**MM Docket 87-268
DTV Rulemaking**

Biennial Review

**Comments of
Hammett & Edison, Inc.
Consulting Engineers**

Comments of Hammett & Edison, Inc.

OET-69 Coverage for a Los Angeles, California, UHF DTV Allotment
(without EC3 Cells)

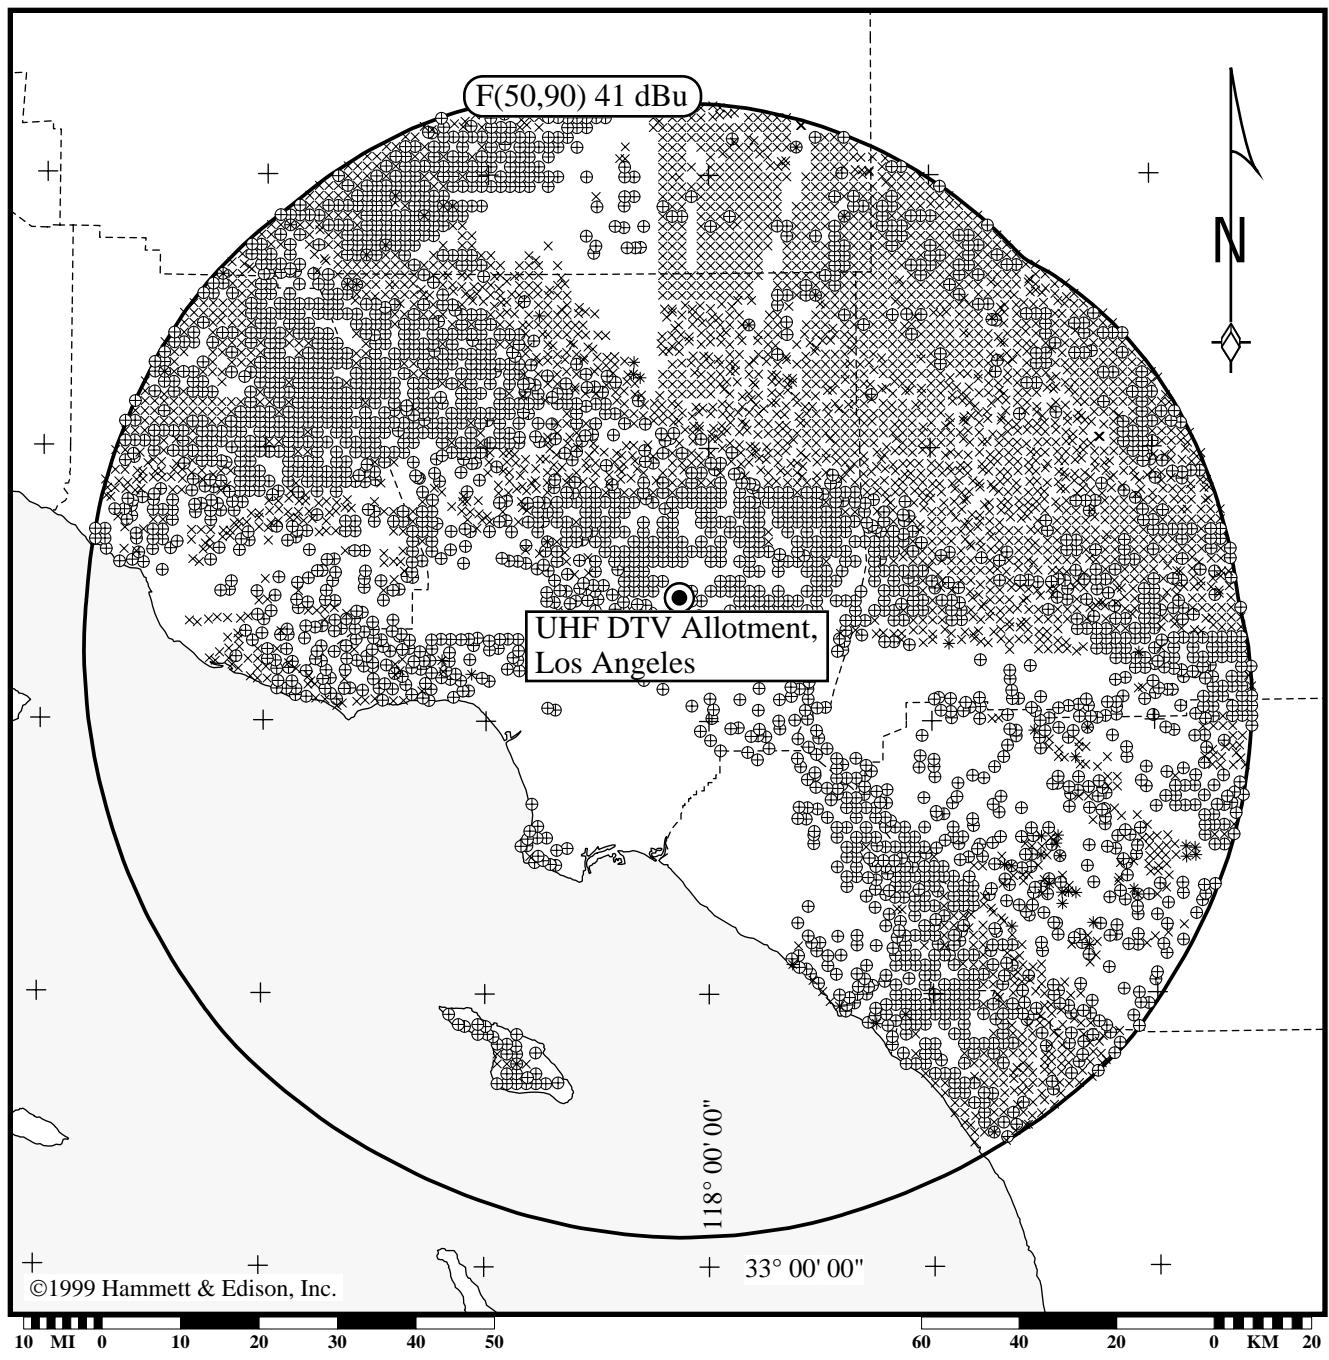
7. On the average, 18.2% of a DTV allotment’s population fell in EC3 cells, which is troubling. It makes little sense to have a 2% *de minimus* criteria for DTV stations, and a 0.5% *de minimus* criteria for NTSC stations, when the underlying prediction model has an average error of 18%. Under the FCC’s *de minimus* policy, a modifying DTV station is generally allowed to cause up to 2% additional interference to an existing NTSC station or to a DTV allotment on the presumption that such additional interference is acceptably minor, *i.e.*, *de minimus*. NTSC stations seeking to modify their facilities are held to a more restrictive criteria, where the loss in population served must be less than 0.5% of the DTV station’s predicted noise-limited, interference-free population. Figure 1A shows the OET-69 coverage for a Los Angeles UHF DTV allotment. At first glance, the white areas, representing cells where 1) the cell was predicted to have a signal strength equal to, or greater than, the station’s DTV threshold, and 2) the cell was predicted to receive interference from any other station. However, when the Longley-Rice EC3 cells are added,

OET-69 Coverage for a Los Angeles, California, UHF DTV Allotment
(with EC3 Cells)

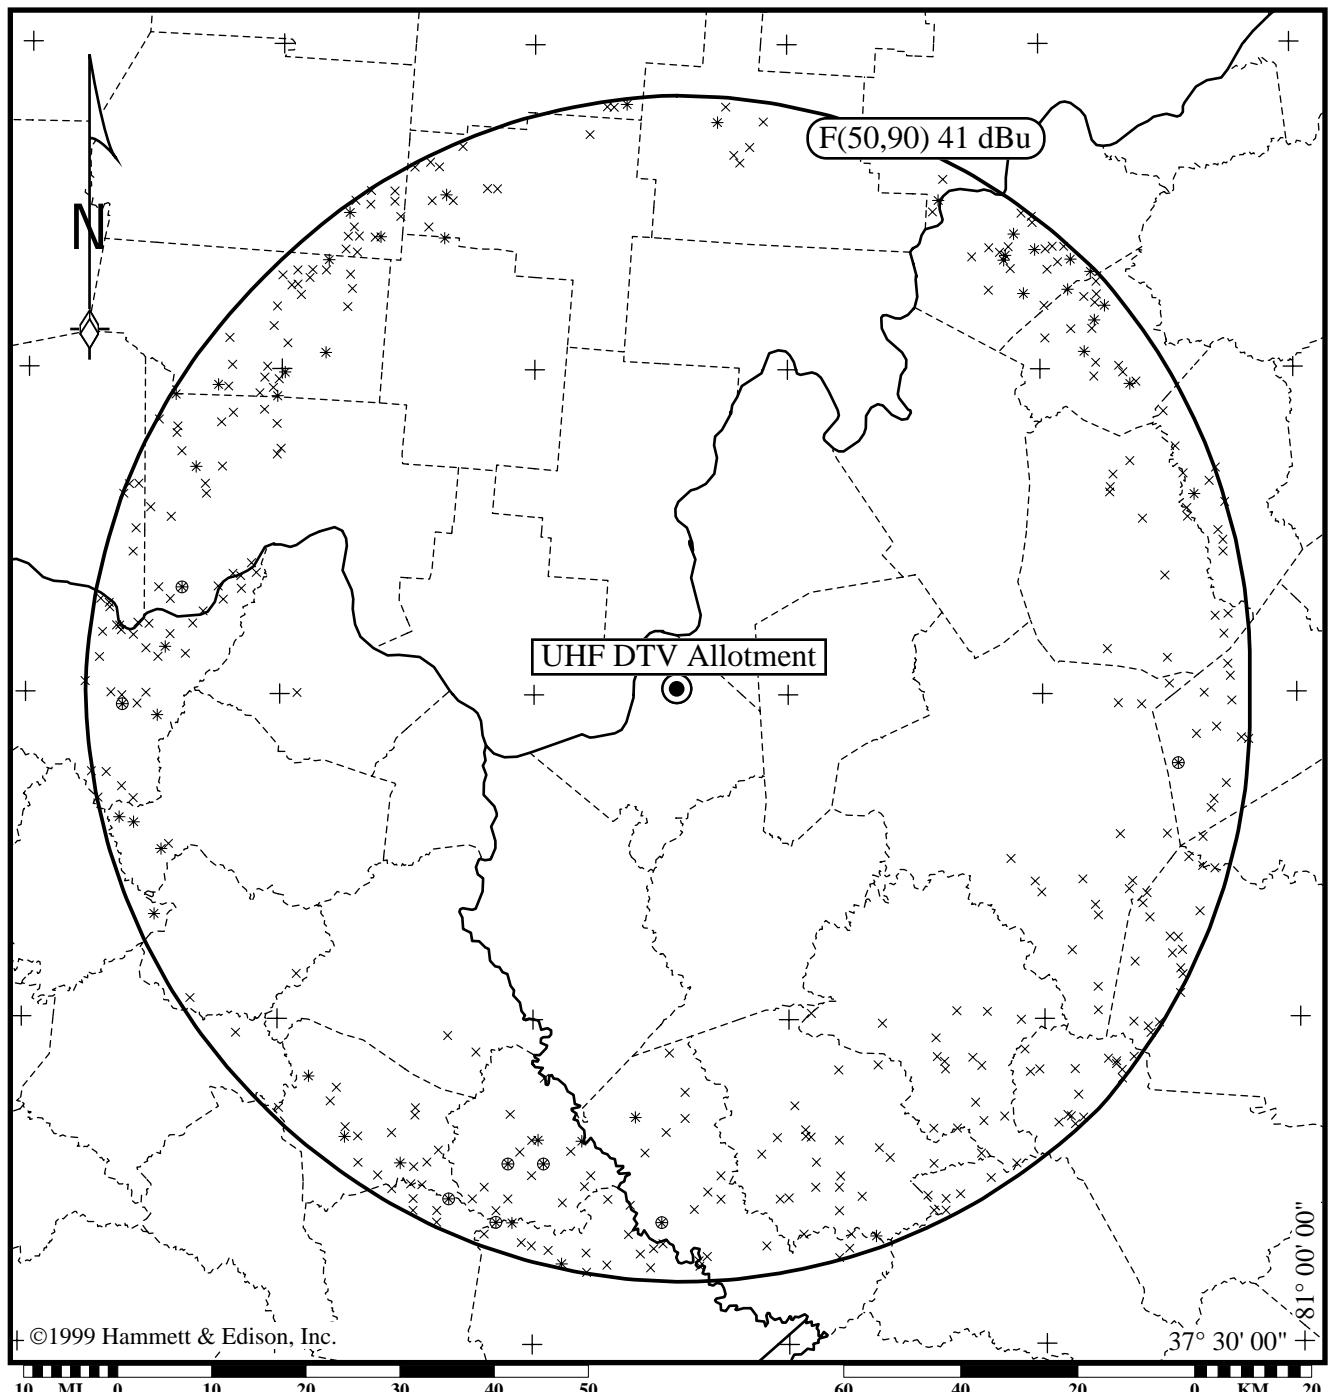
as shown in Figure 1B, things no longer look so good: 30.7% of the cells, containing 9.1% of the allotment's potential population, or well over a million persons, are EC3 cells.

OET-69 Coverage for West Virginia UHF DTV Allotment
(without EC3 Cells)

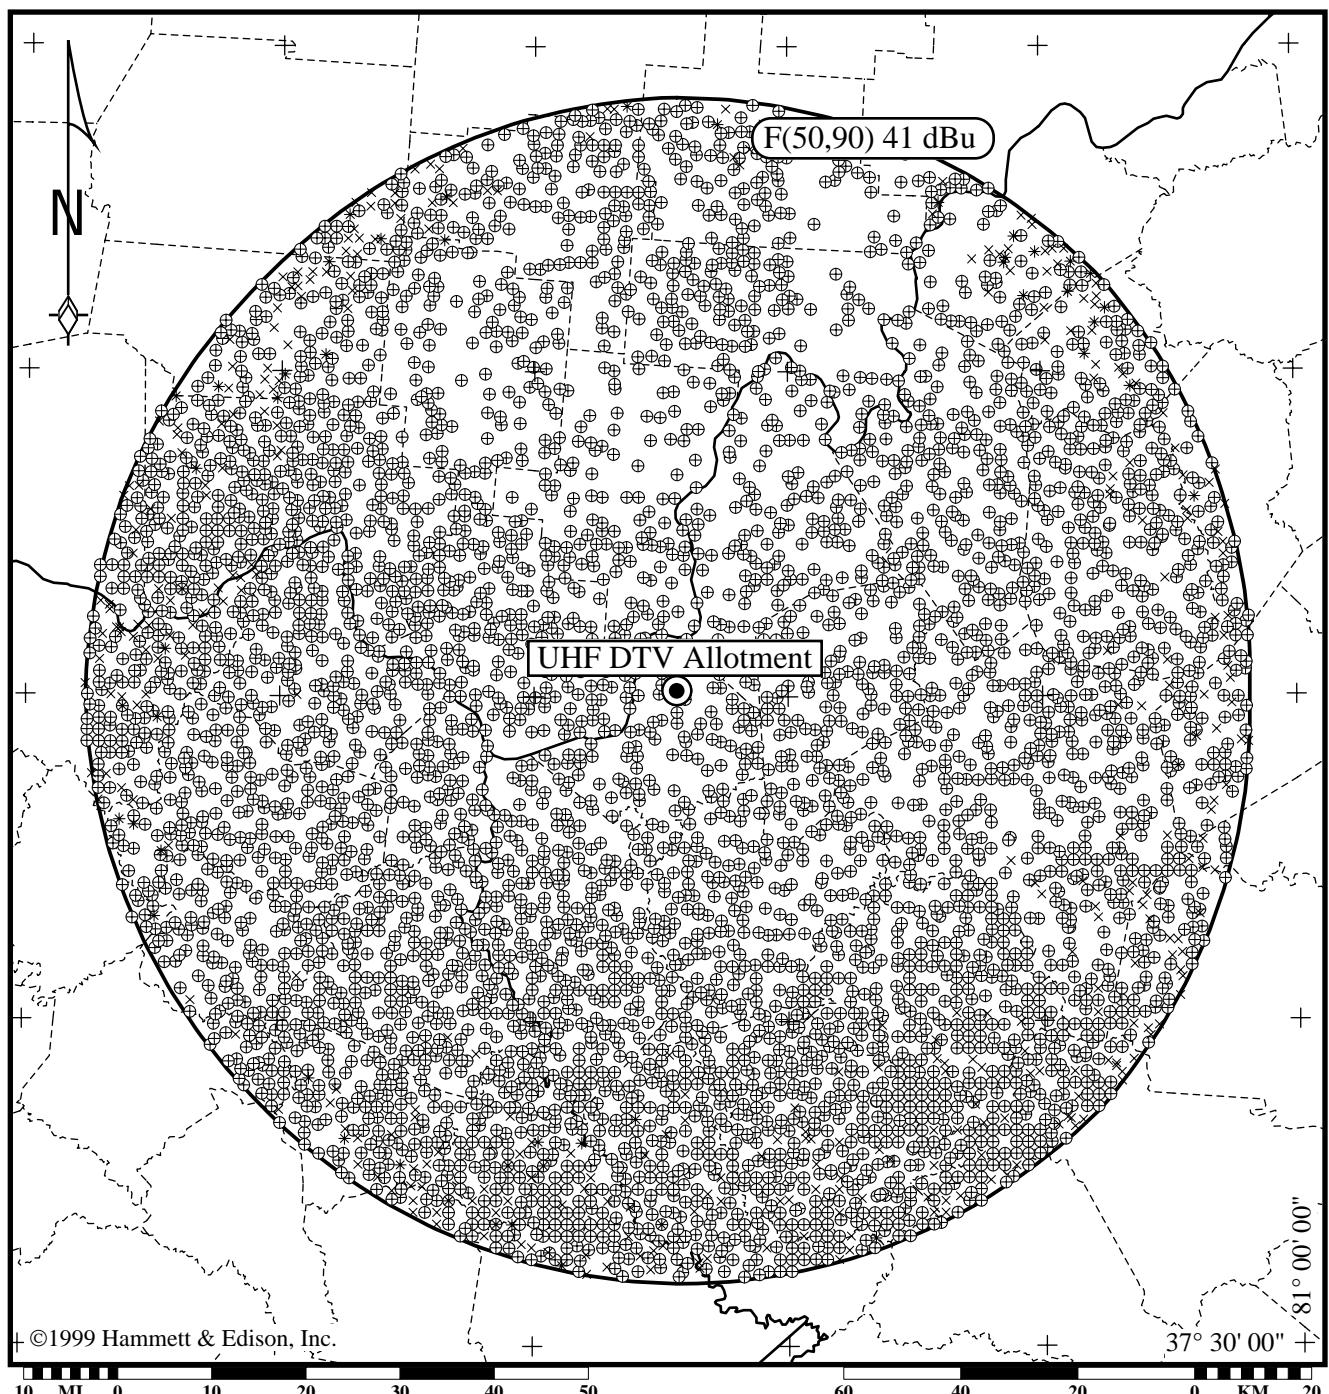
8. Similar EC3 problems exist for the UHF allotment assigned to a West Virginia station. Figure 2A shows the coverage using the FCC method, that is, where EC3 cells are assumed to have interference-free service, and therefore shown as white (no symbol) areas, and Figure 2B shows the coverage with EC3 cells displayed. In this station's case, the EC3 cells represent 59.7% of the station's coverage area and 57.6% of the station's population.

Depression Angle vs. Azimuth to Population Centroids Within 160 km of Mt. Wilson Based on Incorrect FCC Method

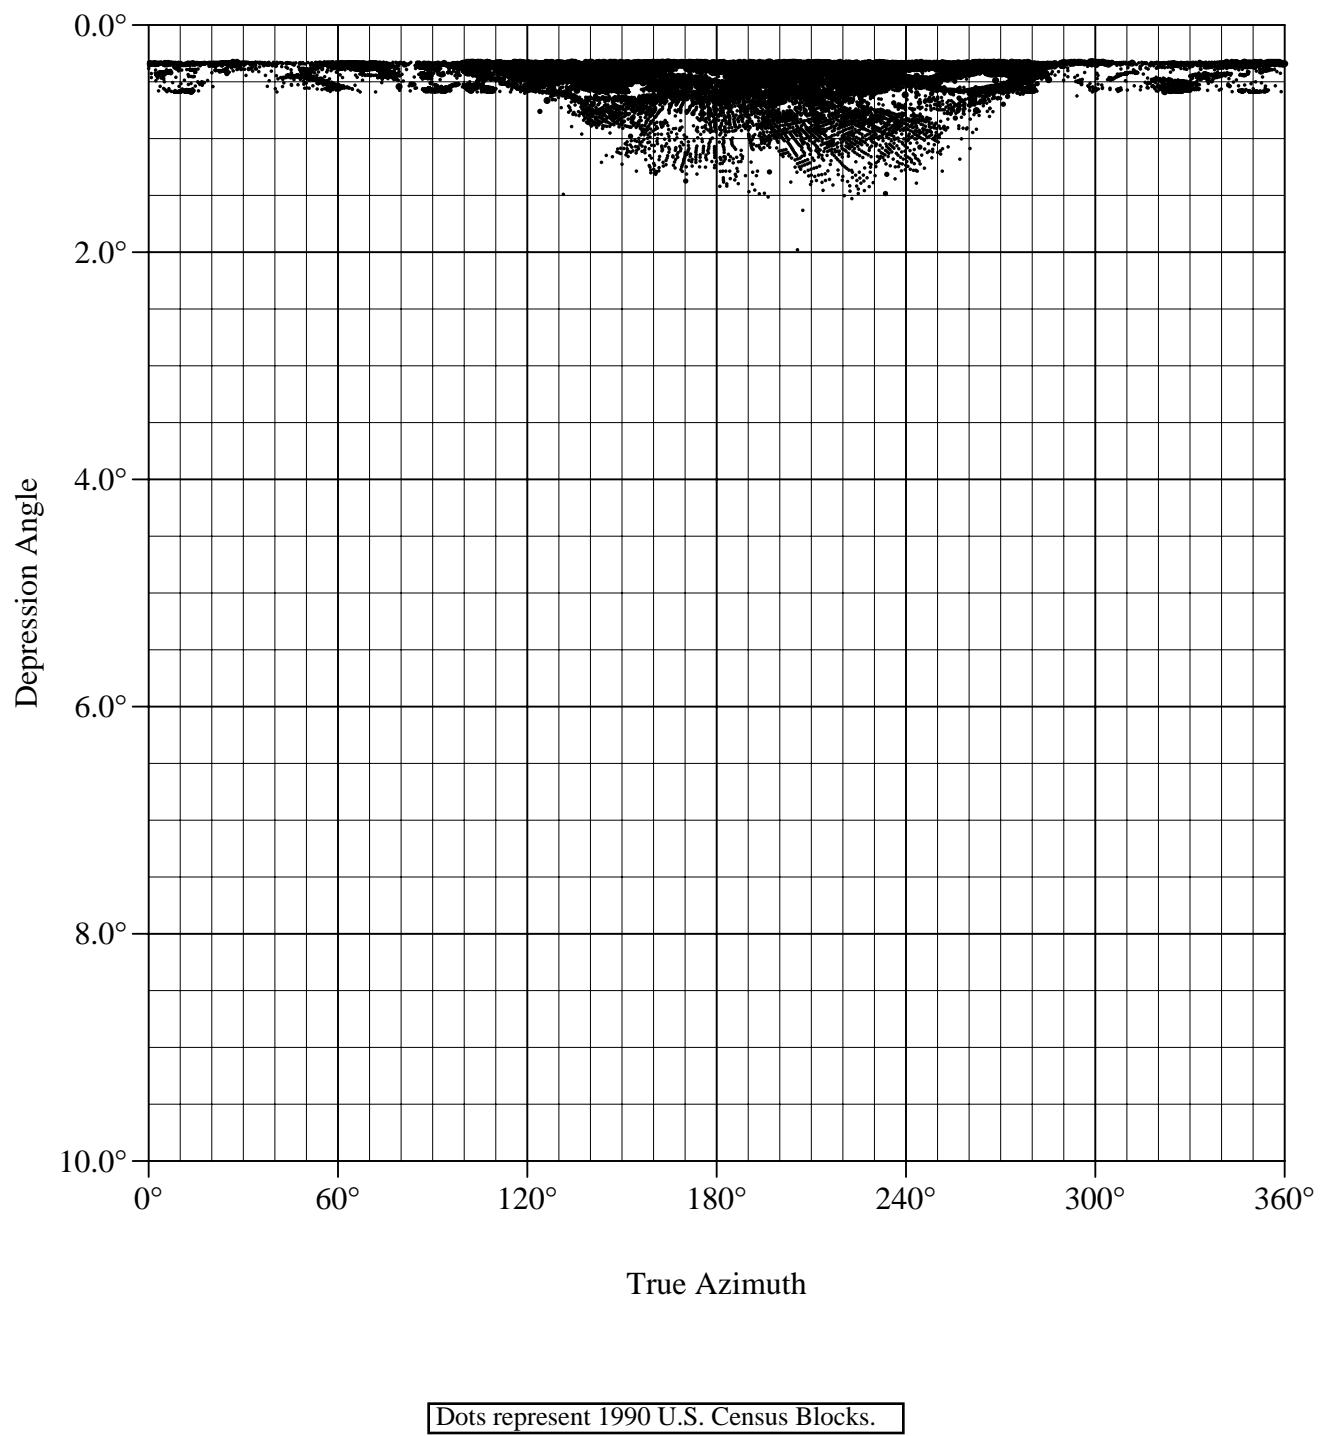
13. To appreciate the magnitude of the problem, Figure 5A shows a plot of depression angles to Census population centroids within 160 kilometers of Mt. Wilson and having line of sight to a center-of-radiation height of 1,817 meters AMSL/80 meters AGL (these are the actual heights proposed for a DTV station at Mt. Wilson). Figure 5B shows those same depression angles based on the incorrect FCC method. Obviously, there is a significant difference and it is again questionable for the FCC to be worrying about 2% and 0.5% *de minimus* interference when such errors in the calculation of depression angles continue to be introduced.

OET-69 NTSC UHF Elevation Patterns: Flat vs. Symmetric

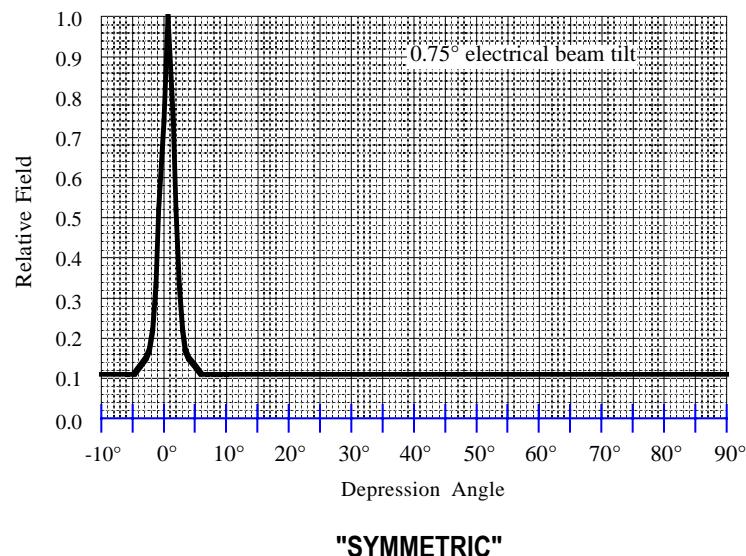
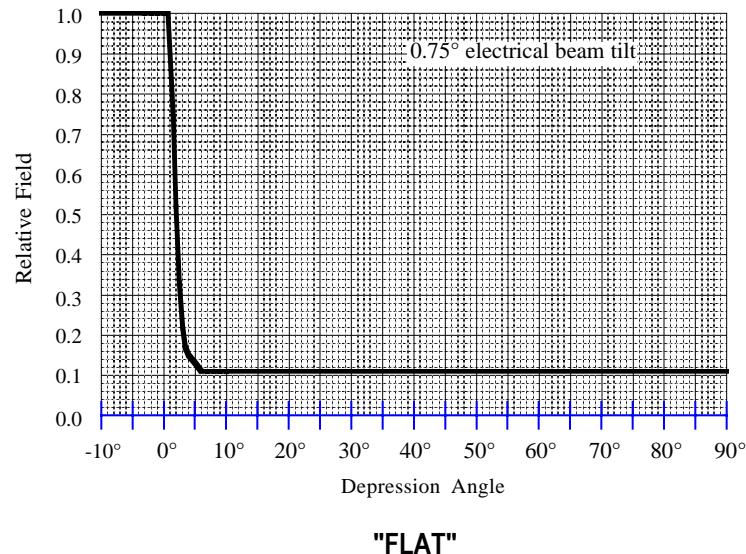
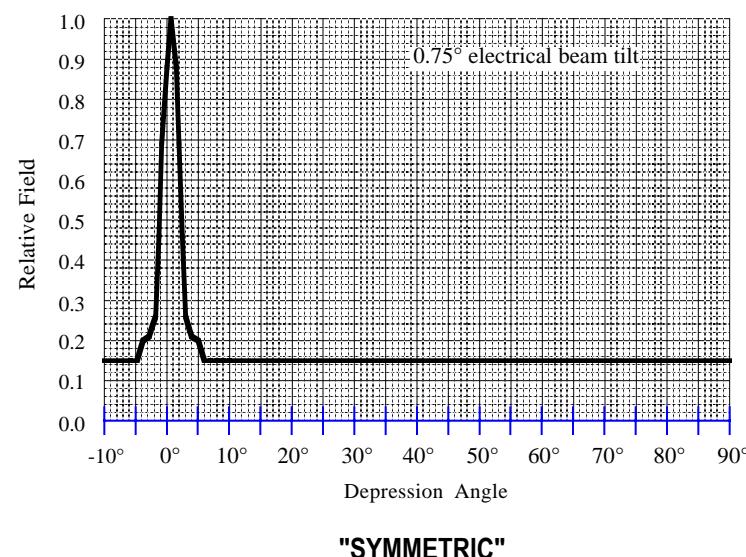
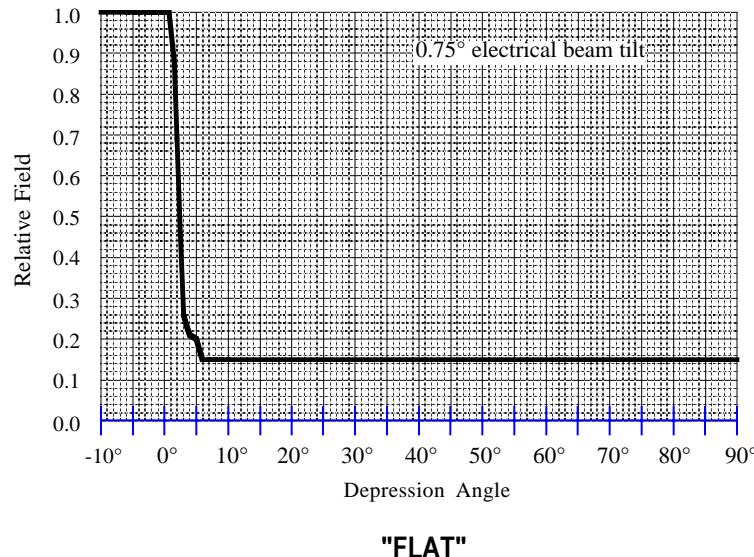
14. OET-69 provides generic UHF NTSC and DTV elevation patterns; these are shown in Figures 6A (for NTSC) and 6B (for DTV). Since these patterns were used to develop the DTV Table of Allotments and the “baseline” noise-limited, interference-free service for NTSC stations and DTV allotments, their use is necessary if current OET-69 interference studies are to replicate the FCC baseline populations. Of course, accurately replicating the FCC baseline populations is critical for determining whether a proposed facility will cause no more than *de minimus* new interference. There are two items to note regarding the OET-69 generic UHF elevation patterns: 1) Table 8 of OET-69 provides values only from 0.75° below the horizontal to 10° below the horizontal (and note that a positive beam tilt indicates an angle *below* the horizontal; that is, a beam tilt of 90° means straight down, and a beam tilt of -90° means straight up), and 2) an electrical beam tilt (“EBT”) of 0.75° for both the NTSC and for the DTV elevation patterns is presumed. Unfortunately, many NTSC stations on tall mountains have more than 0.75° EBT, and many employ a combination of electrical and mechanical beam tilts. Figures 7A and 7B demonstrate why good designs often employ both electrical and mechanical beam tilts. Figure 7A shows a transmitting antenna with a HPBW of 3.6° (corresponding to a Dielectric TFU-18GTH antenna) and with 2° of electrical beam tilt. The site is for a DTV station in the California Central Valley, on a 1,036-meter AMSL mountain approximately 48 kilometers east of the station’s principal community, which has an elevation of about 91 meters AMSL. It can be seen from Figure 7A that 2° of EBT would provide reasonably good coverage of the population distribution (and also that the 0.75° of

17. Hammett & Edison believes that the Commission could make a major step in fixing this portion of OET-69 by allowing, but not requiring, use of the actual elevation patterns employed by existing or proposed stations when making OET-69 interference studies. Although it is realized that the Commission's engineering database regrettably does not include elevation patterns, this omission could be overcome by allowing applicants wishing to use actual elevation patterns to submit those patterns when used in place of a generic elevation pattern. This option should apply for both the proposed facilities and for the facilities of other stations close enough to require study. Also, and as previously discussed, the Commission should require new applications needing to submit a detailed OET-69 style interference study (*i.e.*, all minor-change NTSC applications and all DTV applications that, for
